## **Summary of Amendments to the Design Manual: Barrier Free Access 2008 (June 2019)**

# **Amendments to the Design Manual: Barrier Free Access 2008**

## **( June 2019 )**

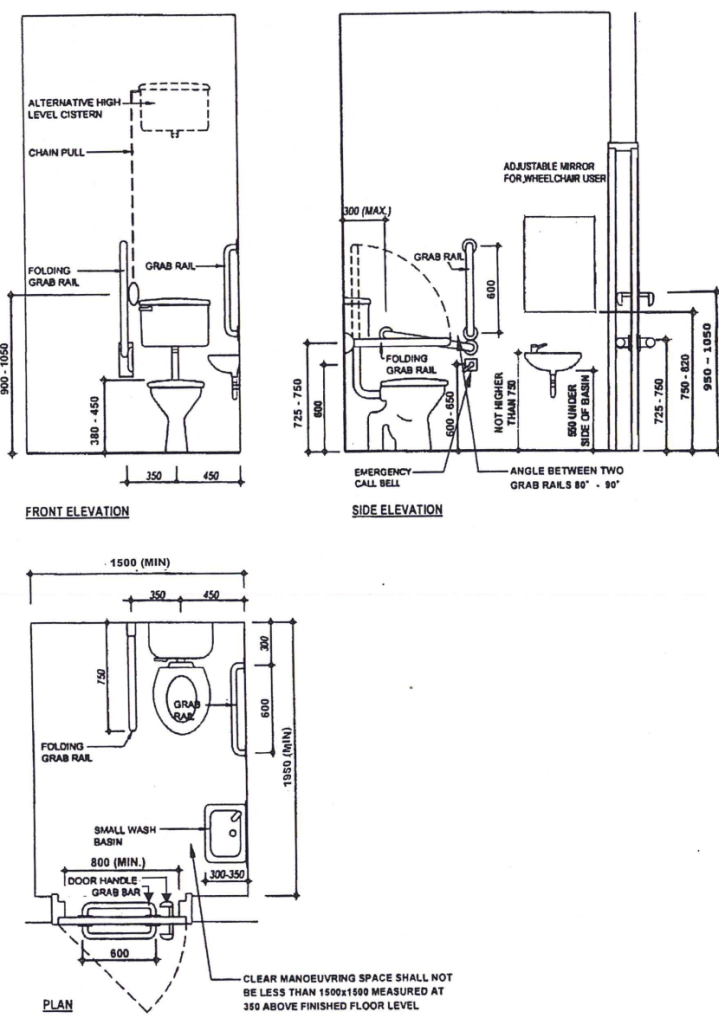
Item	2008 version	Amendments
<p>9. Figure 2 in Division 2 of Chapter 4*</p>	 <p>The diagram shows a typical guest room layout with two beds, a wardrobe, a bathroom, and a clear manoeuvring space. Dimensions are in mm. Key dimensions include: 800 (MIN.) for bed width, 1500 (MIN.) for room width, 1750 (MIN.) for room depth, 800 (MIN.) for bathroom width, 1200 for wardrobe width, 1200 for clear opening, and 330 for clear opening. A note states: 'CLEAR MANOEUVRING SPACE SHALL NOT BE LESS THAN 1500x1500 MEASURED AT 350 ABOVE FINISHED FLOOR LEVEL'.</p> <p>Figure 2 – Typical Guest Room Layout</p>	 <p>The diagram shows the same typical guest room layout with amendments highlighted in yellow. Key amendments include: 'BATHTUB AND/OR SHOWER COMPARTMENT IN COMPLIANCE WITH FIGURE 27', 'CLEAR MANOEUVRING SPACE NOT LESS THAN 1500 X 1500', 'SLIDING DOOR', '1950 (MIN.)', '850 (MIN.)', and '850 (MIN.)'. A note states: 'CLEAR MANOEUVRING SPACE SHALL NOT BE LESS THAN 1500x1500 MEASURED AT 350 ABOVE FINISHED FLOOR LEVEL'.</p> <p>Figure 2 – Typical Guest Room Layout</p>

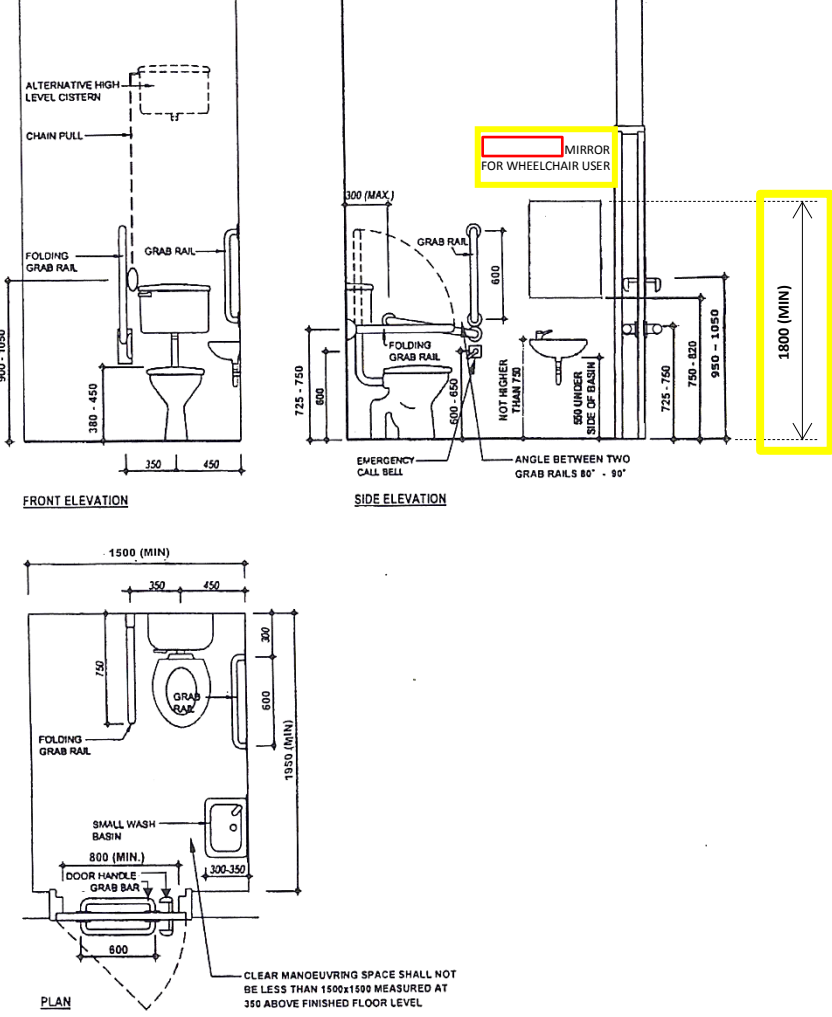
Item	2012 version	Amendments
<p>12. Figure 24 in Division 11 of Chapter 4*</p>	 <p>FRONT ELEVATION</p> <p>SIDE ELEVATION</p> <p>PLAN</p> <p>*ALL DIMENSIONS ARE IN mm DIMENSIONS PRINTED IN BOLD FORM DENOTE OBLIGATORY REQUIREMENT DIMENSIONS PRINTED IN ITALIC FORM DENOTE RECOMMENDED REQUIREMENT</p> <p>(Opposite - Handed Layout is Acceptable)</p> <p><b>Figure 24 – Accessible Toilet</b></p>	 <p>FRONT ELEVATION</p> <p>SIDE ELEVATION</p> <p>PLAN</p> <p>*ALL DIMENSIONS ARE IN mm DIMENSIONS PRINTED IN BOLD FORM DENOTE OBLIGATORY REQUIREMENT DIMENSIONS PRINTED IN ITALIC FORM DENOTE RECOMMENDED REQUIREMENT</p> <p>(Opposite - Handed Layout is Acceptable)</p> <p><b>Figure 24 – Accessible Toilet</b></p>
